Zablocki Transformer Upgrade project – Bid questions**11/17/15**

695-14-140 111 Change Transformers Essential & Non - Essential

ELECTRICAL DUCT BANK DETAIL – SECTION A-A

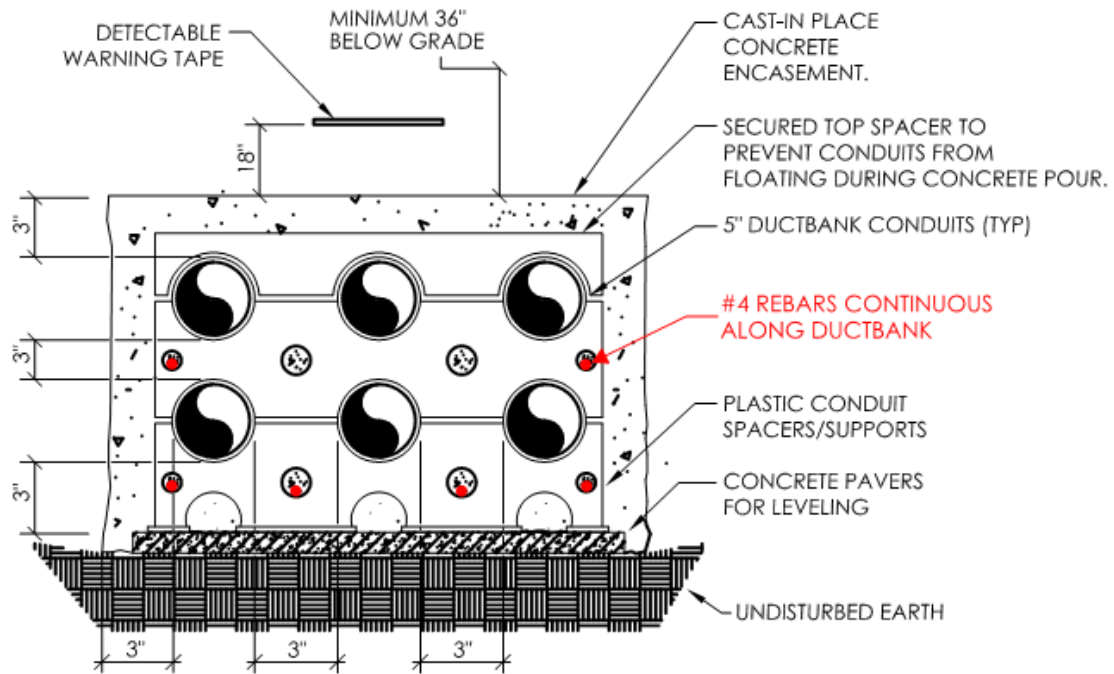
21	<p>Transformer #4 is missing, feeders & Bus connection/modifications.</p> <p>A. Replace previously provide Sheet E001.4 dated 03/02/2015 – 100% SUBMITTAL; Sheets ES101, E100, E101.4, E701.4, E102 and E702, dated 01/07/2015 – 95% SUBMITTAL with Sheets dated 06/24/2015 – ISSUED FOR BID AND CONSTRUCTION.</p>
22	<p>Duct bank is missing rebar.</p> <p>A. Provide #4 rebar's continuous along duct bank as indicated in red on detail attached below.</p>
23	<p>Conduit inside & overhead for Medium voltage E MT or Rigid.</p> <p>A. Medium Voltage conduits inside and overhead (within the transformer vault/electrical room shall be 4" Rigid or IMC.</p>
